Community Appeal to the Redondo Beach City Council of Planning Commission Approval of Development Proposed at 521-527 S Broadway

Basis of this Appeal

Units on 700 block of S. Broadway

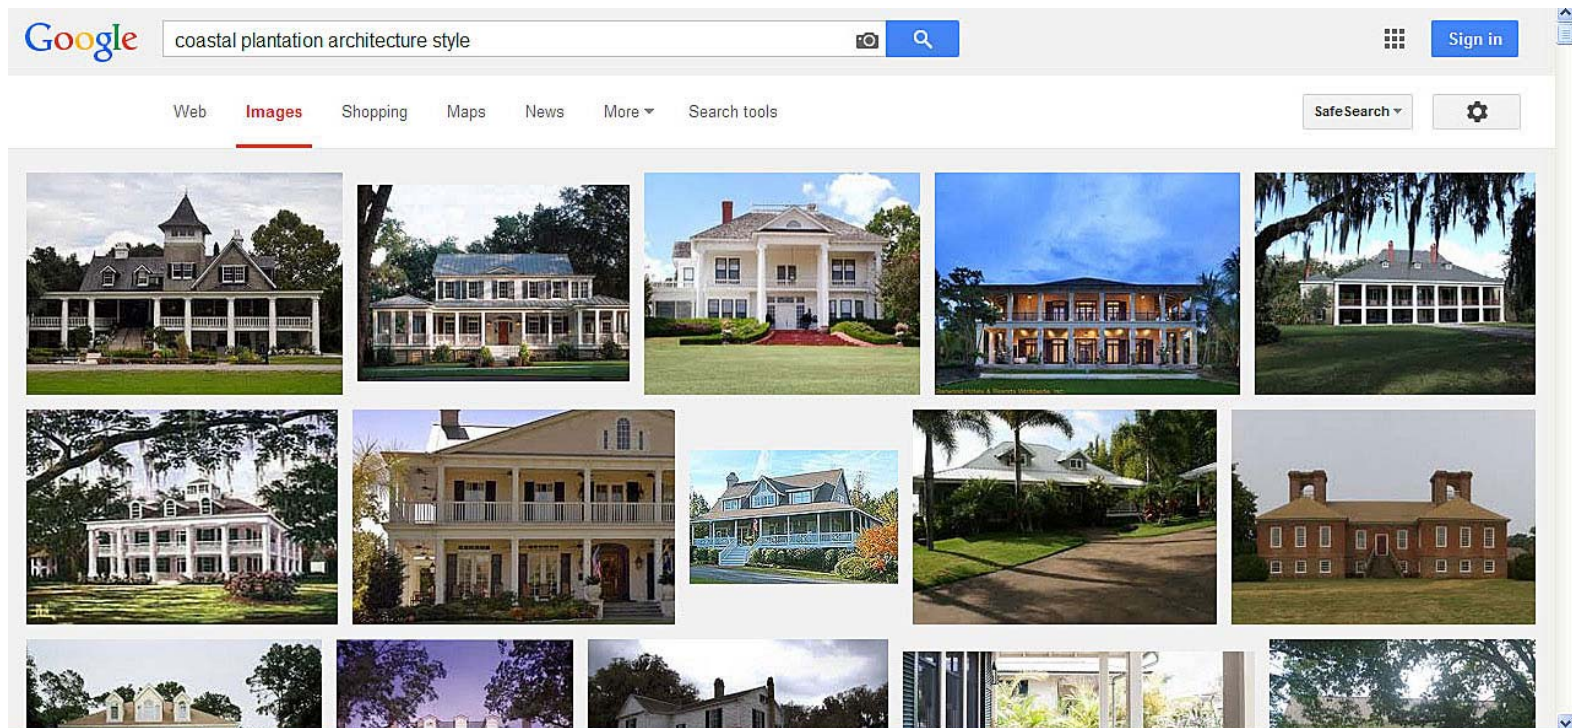
- This bears no resemblance to what can be found as the *Coastal Plantation* architectural design...

*There was no hearing on this dev't,
and it is not within eyesight of 521-527*

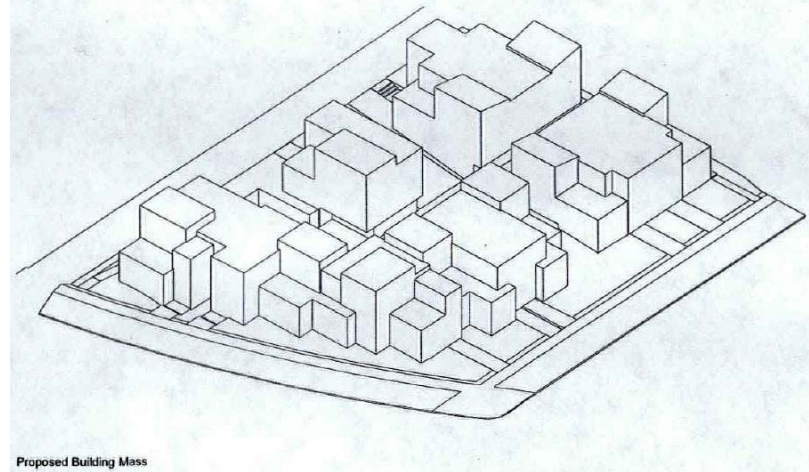
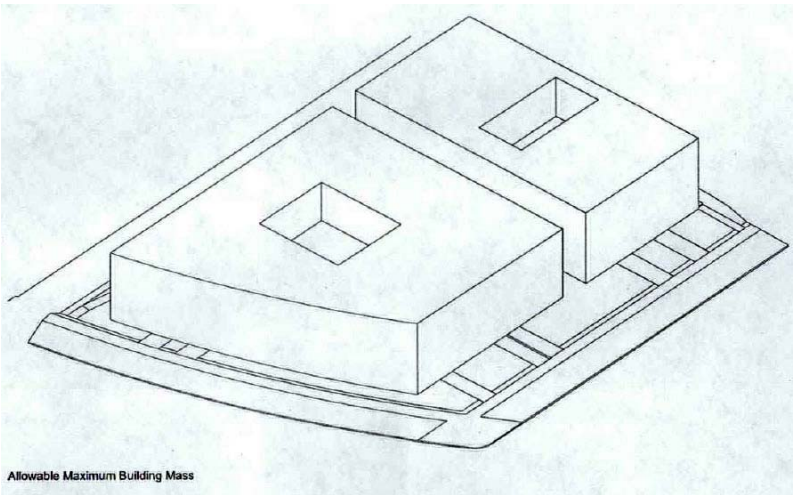
- The curved property setback along Sapphire should share front setback properties as it has residence entrances, and also faces homes across Sapphire.

- The maximum-allowed mass on left (sans RDG), and the proposed project “boxy-massing” on right, both show very close proximity to the Sapphire-side sidewalk for the full length from Broadway to the alley. Note also that there is a literal *wall* along Sapphire. 35

- The Sapphire setback should *at minimum* be a *graduated setback* – where the setback at Broadway is the *front* setback distance, and the setback then shrinks, linearly, to a *side* setback distance as the lot curves from Broadway to the alley. In the picture above, red resembles the project's proposed setback, yellow the graduated.
